Design Hazard Review: DSRP Bench Unit

SLIPSTREAM PILOT TEST UNITS FOR DIRECT SULFUR RECOVERY PROCESS AND ADVANCED HOT GAS PROCESS

August 2000

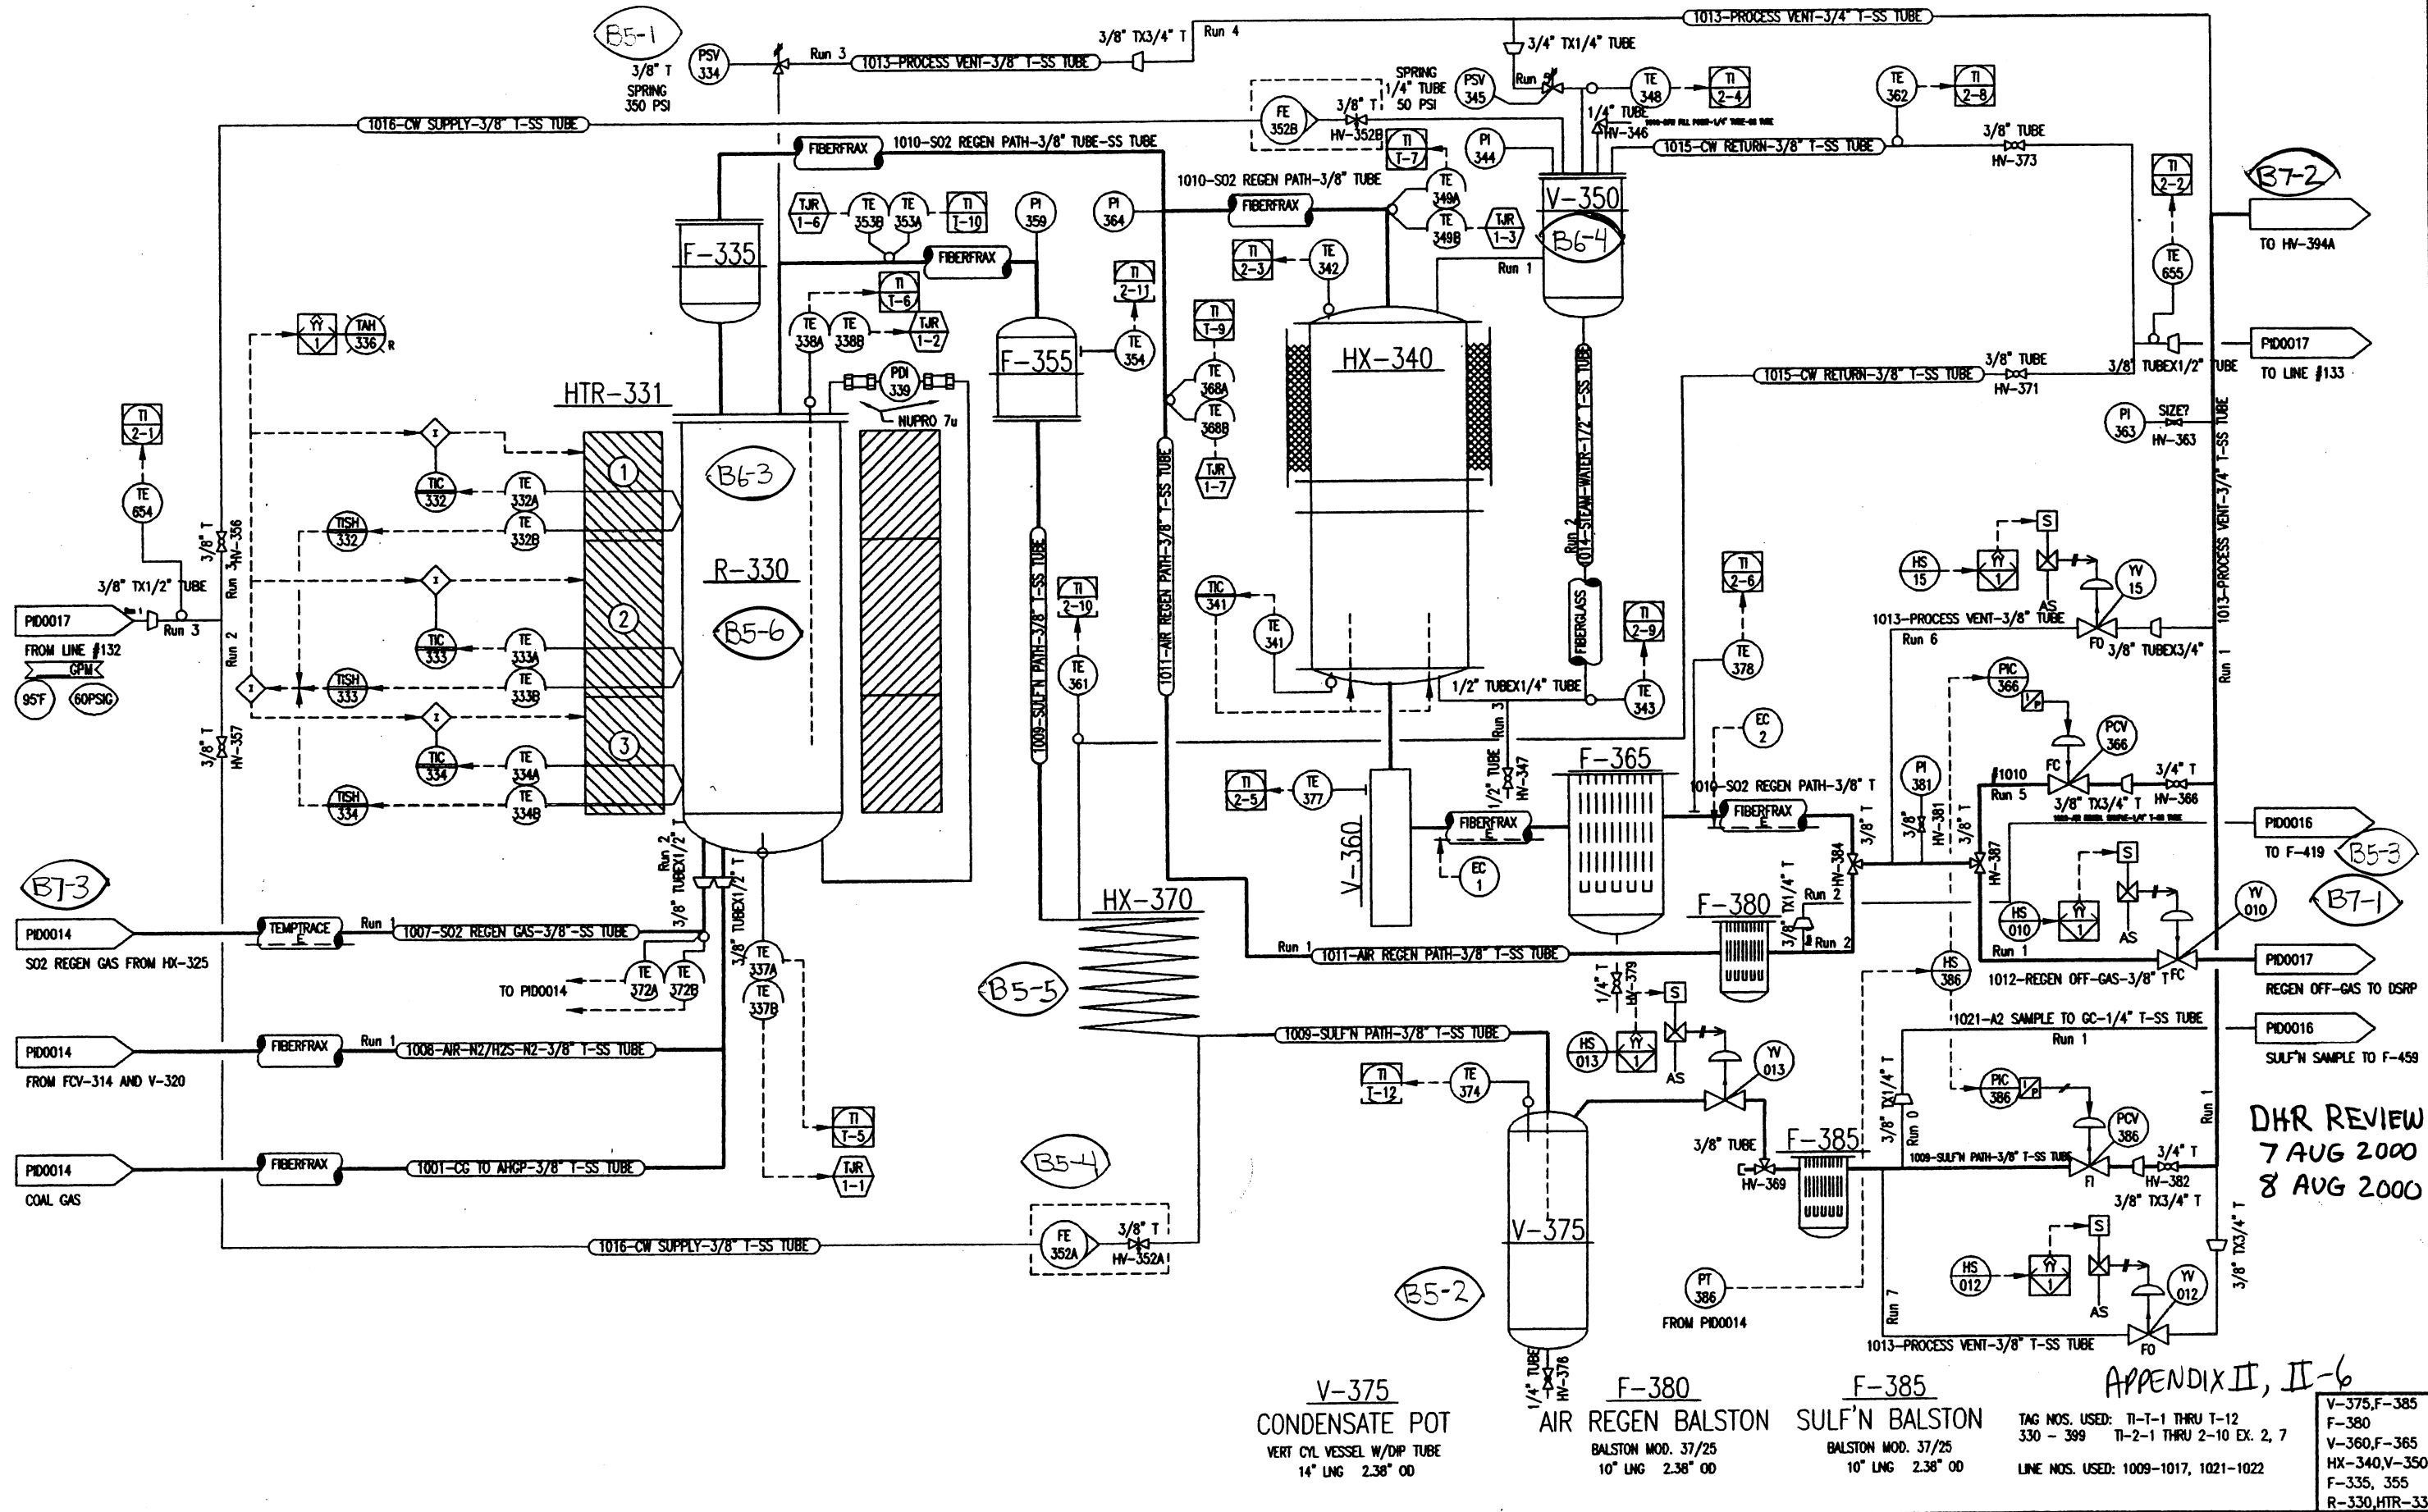
B5-4	PID-0015 Cooling water FE-352A Rotameter	High pressure. FE-352A installed for lower pressure service.	CW supply to RTI from KBR closed loop cooling at 140 psig.	S-FE-352A fails due to over pressure.	Provide rotameter for the higher- pressure service.	RTI	
B5-5	PID-0015 Cooling water	Leak. Process leak into cooling water.	Corrosion failure of HX-370 condenser tube.	S-Potential for over pressure failure of rotameters in CW supply line.	Consider adding check valve in CW supply lines.	RTI	
B5-6	PID-0015 R-330	Contaminants. Oxygen in coal gas.	KBR upset, startup, or S/D.	O-Potential for high reactor outlet temperature.	• Provide typical oxygen concentrations in KBR syngas. • Review concentrations and assess process effects and define action plan, if required.	SCS RTI

B6-3	PID-0015 R-330	High flow/high velocity through R-330. Material of construction.	Rapid process depressurization.	O-Potential for sorbent carryover and distributor damage.	Filler F-335 provided as barrier and collector.	None.		
B6-4	PID-0015 V-350	Tube coil may be fabricated from copper.		O-Material selection not per design requirement.		<ul style="list-style-type: none"> Confirm MOC for tube coil. If coil is copper, replace with stainless steel.

AHGP FIELD TEST BENCH UNIT	P&ID - ANALYTICAL	DOE-FETC
Advanced Hot Gas Desulfurization	Wilsonville, AL	
		DWG. NO. PID0016

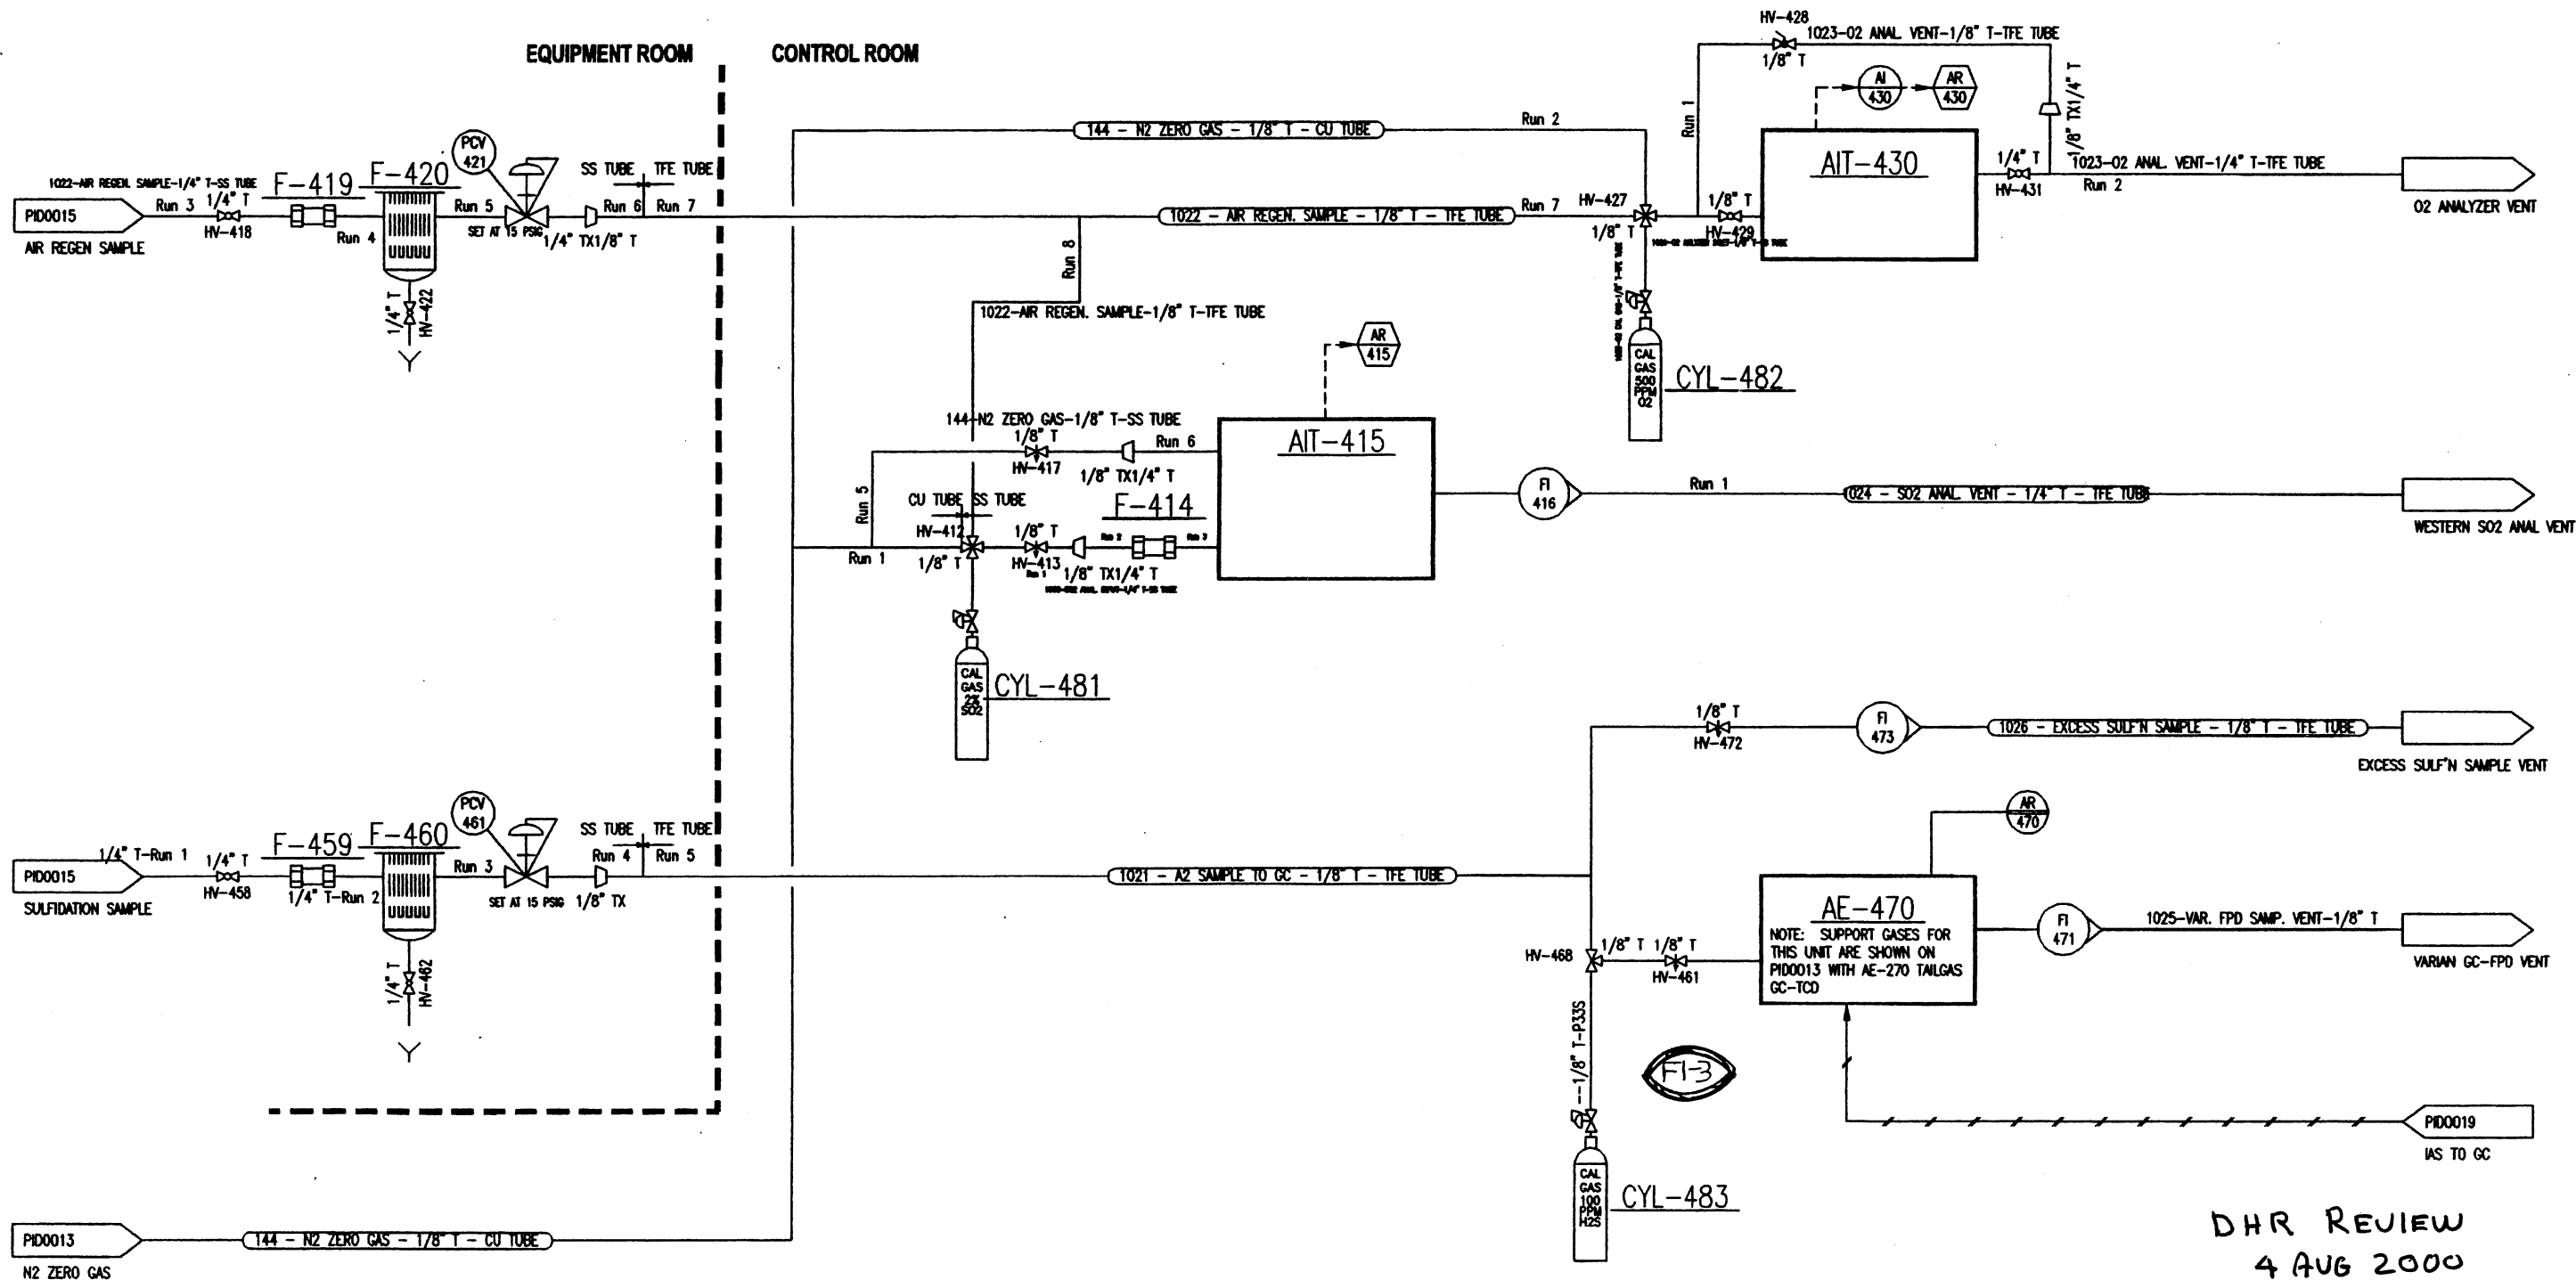
STUDY REF	LINE NO EQUIPMENT NO OTHER	OPERATING DEVIATION POSSIBLE CONDITION GUIDE WORD	POSSIBLE CAUSES OF DEVIATION PROBLEM	CONSEQUENCES & REASONS FOR ACTION O-OPERABILITY S-SAFETY HAZARD	EXISTING PRECAUTION	RECOMMENDED ACTION REQUIRED NOTES/QUERIES	ACTION BY	FURTHER IMPLICATIONS FOLLOW-UP REVIEW COMMENTS
F1-1	PID-0013 HX-210 A-1 Sample Coil. Line 117-ROG sample.	Leak/tube rupture.	Corrosion.	O-S/D DSRP to replace coil and perform maintenance.		Consider installing high temperature valve at tail gas sample line tie-in to perform replacement/maintenance of coil.	RTI	
F1-2	PID-0013 HX-225 Sample Cooler.	High pressure.	PCV-223 regulator failure while blocked in.	O-Potential for over pressure and damage to HX-225.		<ul style="list-style-type: none"> Determine MAWP/temp of HX-225. Consider PSV for over pressure protection. 	RTI	
F1-3	PID-0013/PID-0016 Support gas cylinders.	Leak. H ₂ /N ₂ cylinders.	Fusible plug failure from service age/pressure creep.	S-Potential for flammable mixture or low oxygen trailer atmosphere.	HVAC system designed for 4-6 volume change per hour.	<ul style="list-style-type: none"> Confirm/test volume change rates. Leave HVAC on when trailer not occupied and cylinders are in trailer. Include in procedure checklist. 	RTI
